**CASE / FORD NEW HOLLAND - serija 40 & 10**

**Br. art. 3482 600 105**

Sl. 1: Jednostruka spojnica od 330 mm, sa membranskom oprugom

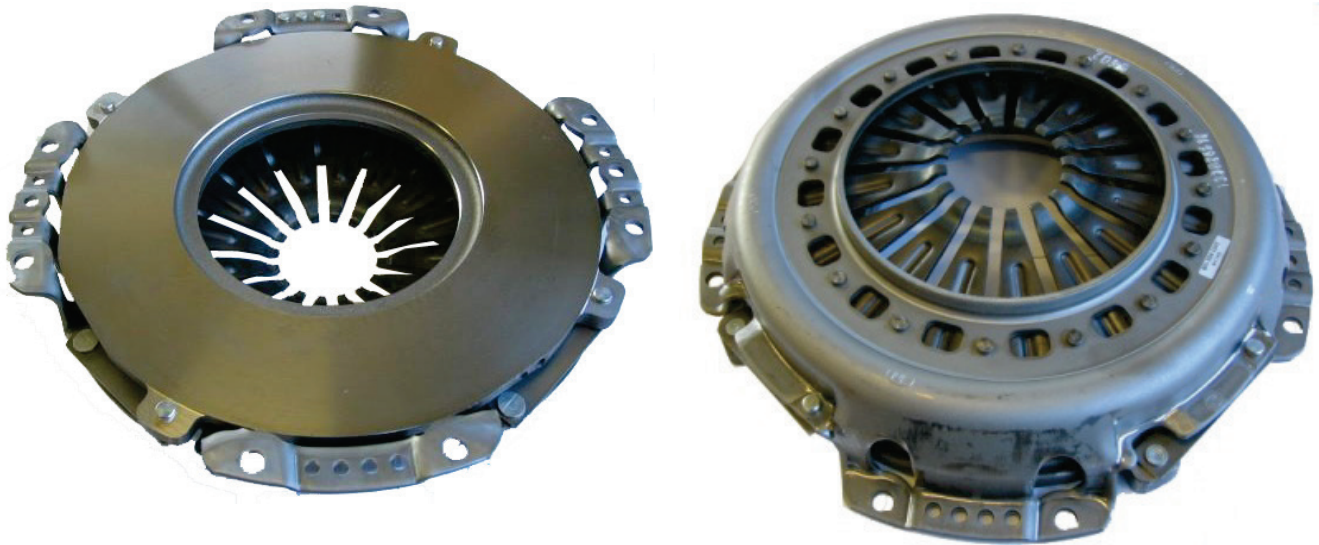
Ako se 4-poluzna spojnica sa navojnom oprugom zameni SACHS spojnicom s membranskom oprugom, segmentni limovi više nisu potrebni.

SACHS spojnica s membranskom oprugom sme da se ugradi samo sa SACHS diskom spojnice (vidi tabelu).
